16 TERRESTRIAL ECOLOGY

16.1 ARID RECOVERY

Figure 16.1 Occurrence of the Orange-bellied Parrot

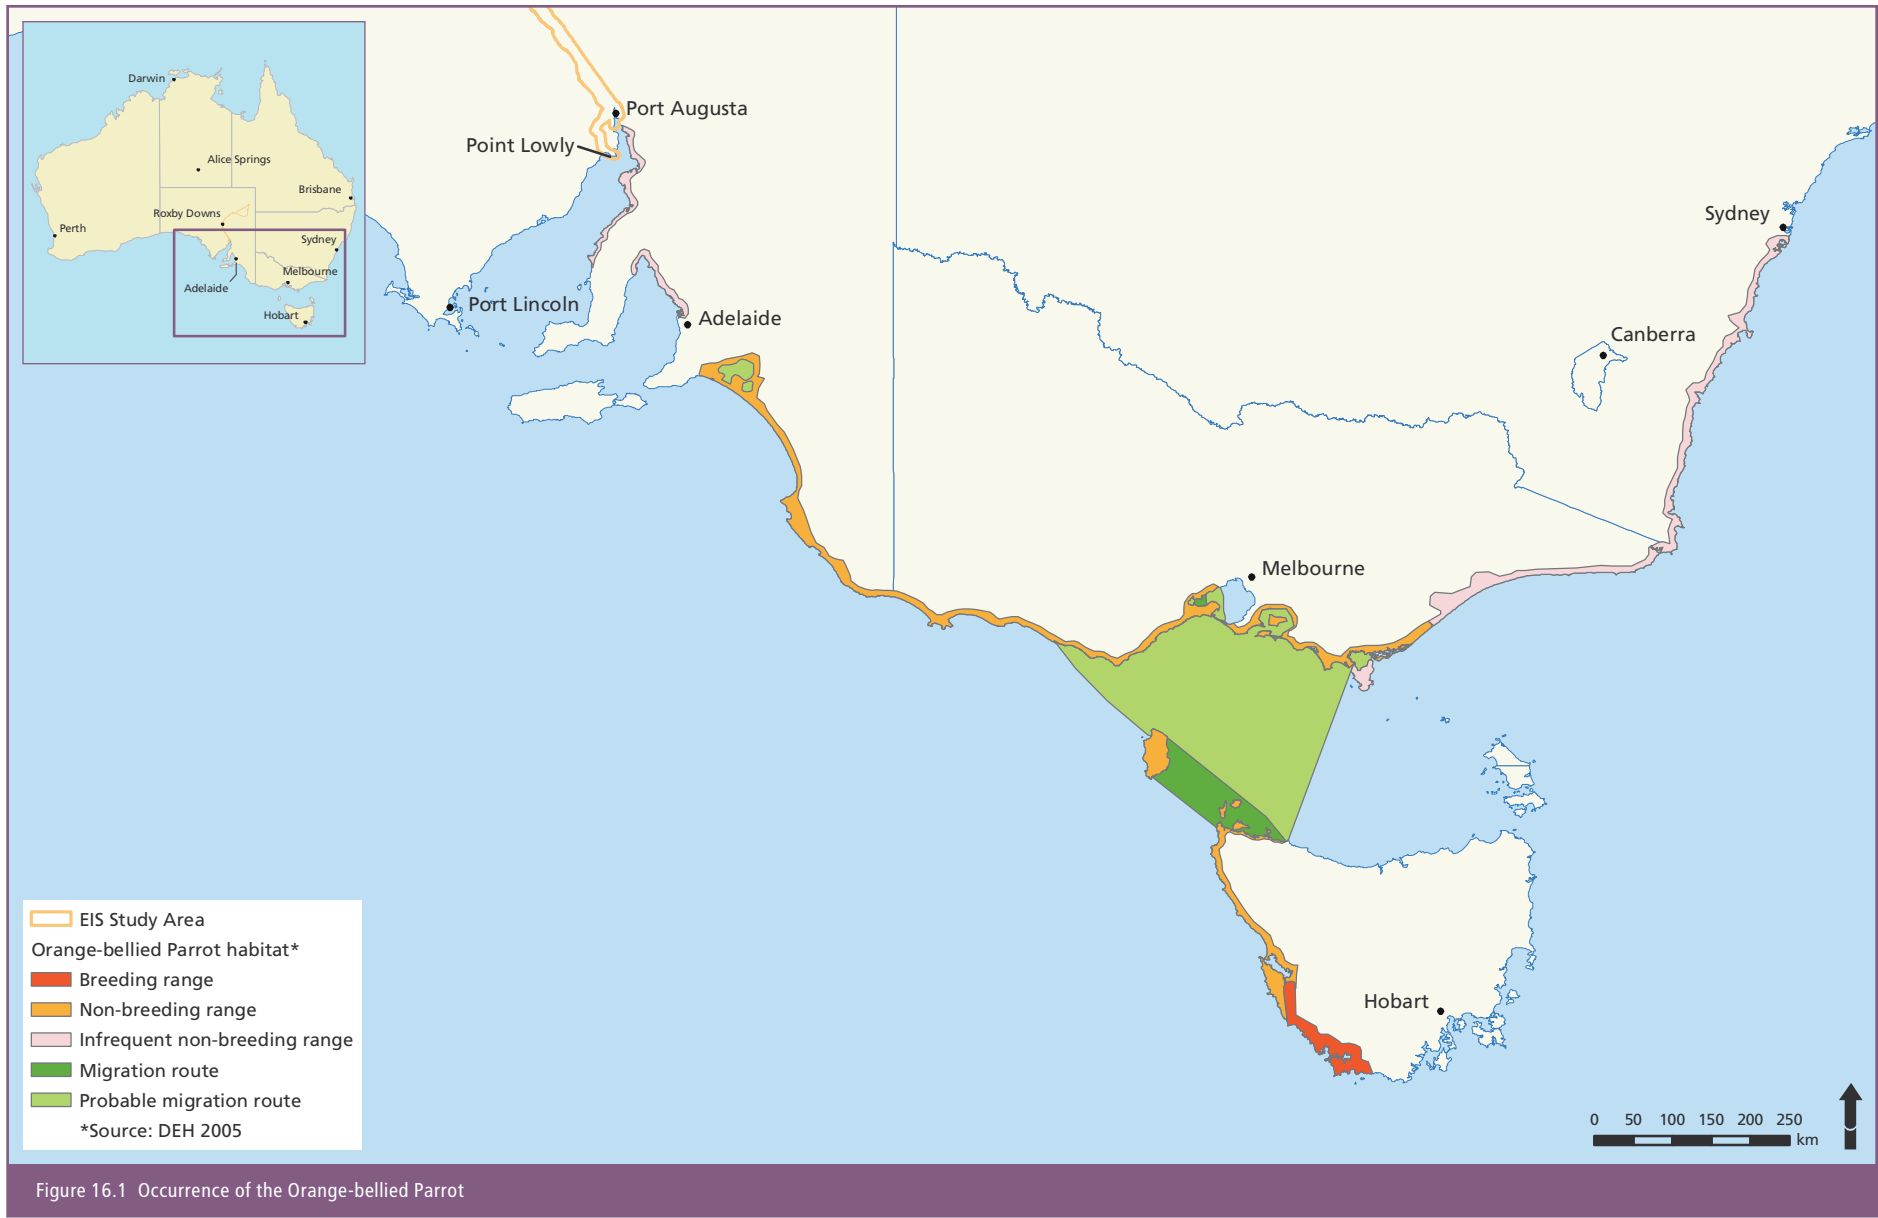
Concern was raised that the Draft EIS did not address potential impacts on the Orange-bellied Parrot. The submission noted that this species has feeding grounds in the Winninowie Conservation Park, which is approximately 15 km from the proposed landing facility.

The Orange-bellied Parrot is not a species known to utilise habitats in the area investigated for the proposed expansion of Olympic Dam and would not be affected by the expansion project.

Although the parrot's range is considered to include the eastern side of Upper Spencer Gulf (Australian Department of Environment, Water and Heritage (DEWHA) 2010, see Figure 16.1 of the Supplementary EIS), the Winninowie Conservation Park (WCP) is not considered to be a critical feeding habitat for the species. As shown in Figure 16.1, its core range is presently restricted to coastal regions of the far south-east of South Australia, southern Victoria and western Tasmania (DEWHA 2010; Birds Australia 2008; Parrot Society 1997).

The breeding range of the species is limited to south-west Tasmania (see Figure 16.1 of the Supplementary EIS), where individuals return to breed in summer after visiting their winter feeding grounds (DEWHA 2010; Orange-bellied Parrot Recovery Team (OBPRT) 2006). The species is 'rarely recorded from west of the Murray River in South Australia' (OBPRT 1998). As shown in Figure 16.1, the eastern side of Spencer Gulf is classified as 'infrequent non-breeding range', and the western side of the gulf, including the proposed locations for the landing facility and the desalination plant, is not included in the range of this species.

Figure 16.4 Areas of suitable habitat for Plains Rat in the southern infrastructure corridor

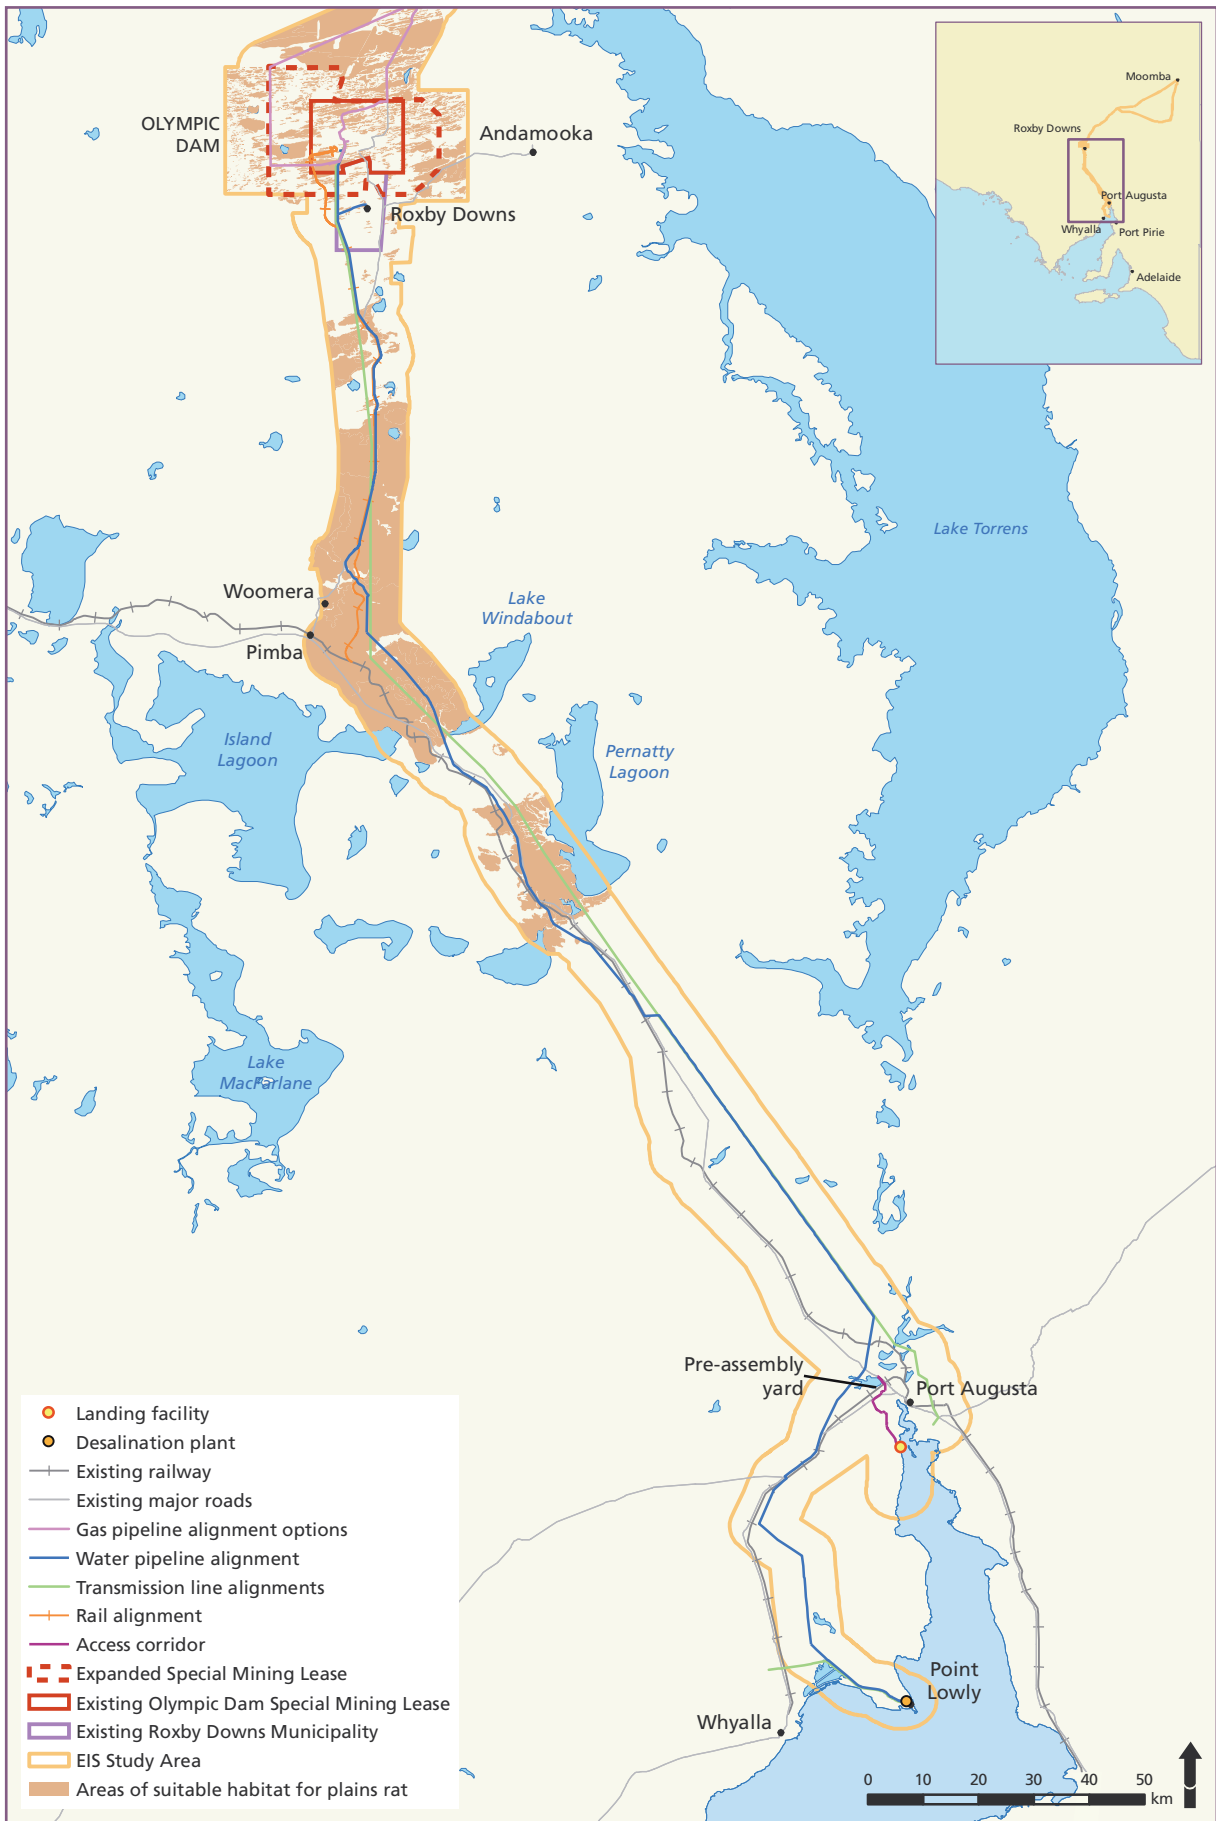
A more detailed definition was sought of the area of habitat suitable for colonisation by populations of Plains Rat displaced during the mine expansion.

Section 15.3.2 of the Draft EIS identified areas of low chenopod shrubland and cracking clay plains considered typical habitat for *Pseudomys australis* (Plains Rat) to the north, south, east and west of the Special Mining Lease (SML). These areas favoured by the Plains Rat in the Olympic Dam region were identified on Figure 15.3 of the Draft EIS, using numbers to demarcate chenopod shrubland. This is reproduced in Figure 16.3 of the Supplementary EIS. Areas of habitat suitable for the Plains Rat in the vicinity of the infrastructure corridor (northern sections) were clearly marked on Figures N1.4a to N1.4c of Appendix N of the Draft EIS, and these areas have been reproduced in Figure 16.4 of the Supplementary EIS.

Section 15.5.5 of the Draft EIS acknowledged that some populations of the Plains Rat in the vicinity of the expanded mine would be displaced by construction activities. However, it was noted that the Plains Rat is a mobile species, regional populations tend to fluctuate in number and are unlikely to establish regular patches of habitat or refugia: therefore it is expected that displaced populations would easily colonise adjacent areas of suitable habitat (as marked on Figures 16.3 and 16.4). It was further noted in Section 15.5.5 of the Draft EIS that the Plains Rat population density fluctuates greatly depending on climatic conditions, erupting into plague proportions during periods of peak abundance. This indicates that displaced populations would assimilate with resident groups if adjacent areas of suitable habitat were already colonised.

Figure 16.5 Monthly summary of number of waterbirds recorded at local non-toxic waterbodies compared to TRS in FY09

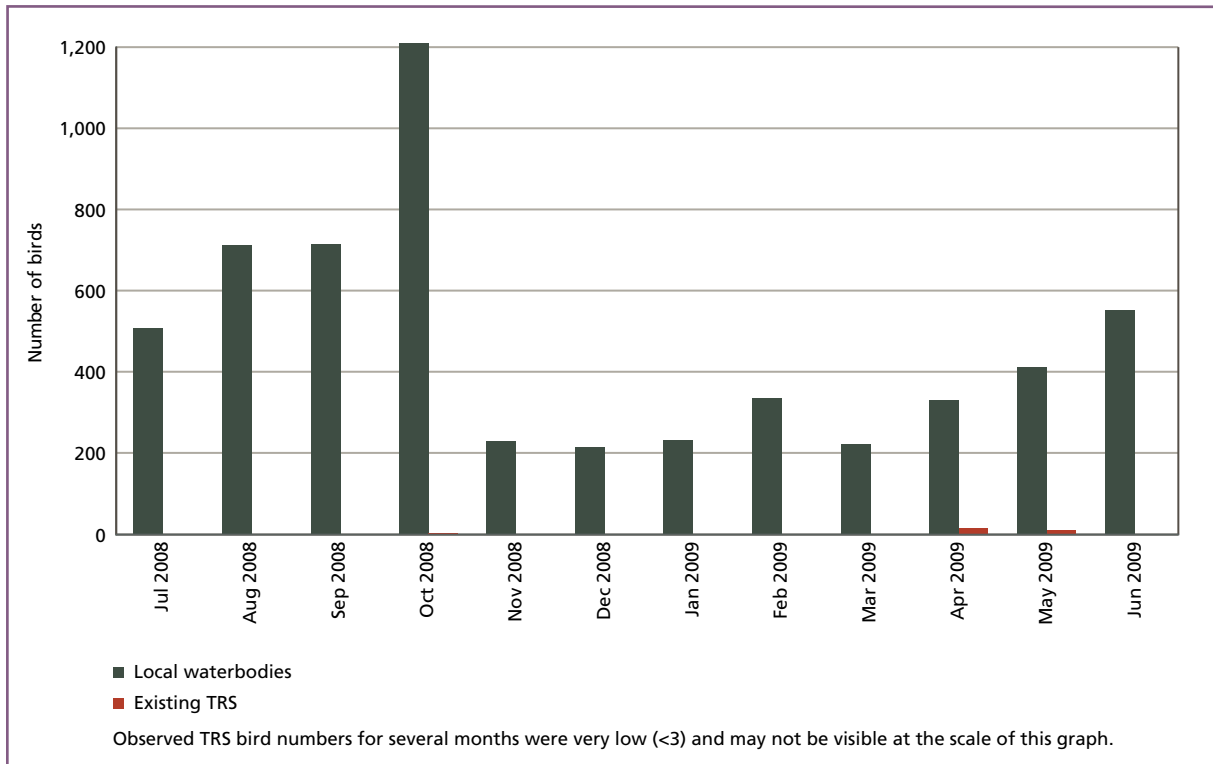
- confirmation of bird death numbers from the existing operation
- the outcomes of previous monitoring and how this monitoring has led to improvements in deterring birds from the tailings retention system (TRS)
- how future monitoring would occur given the large size of the tailings storage facility (TSF) cells
- the apparent separation between bird deaths for the existing and proposed expanded operation and BHP Billiton’s Sustainability Charter
- what offset is proposed to compensate for bird deaths
- whether the proposed expansion could also reduce bird deaths from the existing operation.

- The large number of birds recorded at local non-toxic waterbodies continues to demonstrate the limited number of birds from local and nomadic bird populations that visit the TRS, as is shown in Figure 16.5 of the Draft EIS
- Not all birds that visit the TRS are recorded as mortalities, as is shown in Figure 16.6 of the Draft EIS
- Anecdotal evidence suggests that a considerable proportion of birds that do visit the TSF are able to leave. This is supported by very few observations of birds that show signs of having visited the tailings (e.g. staining of feathers) that are also sick.
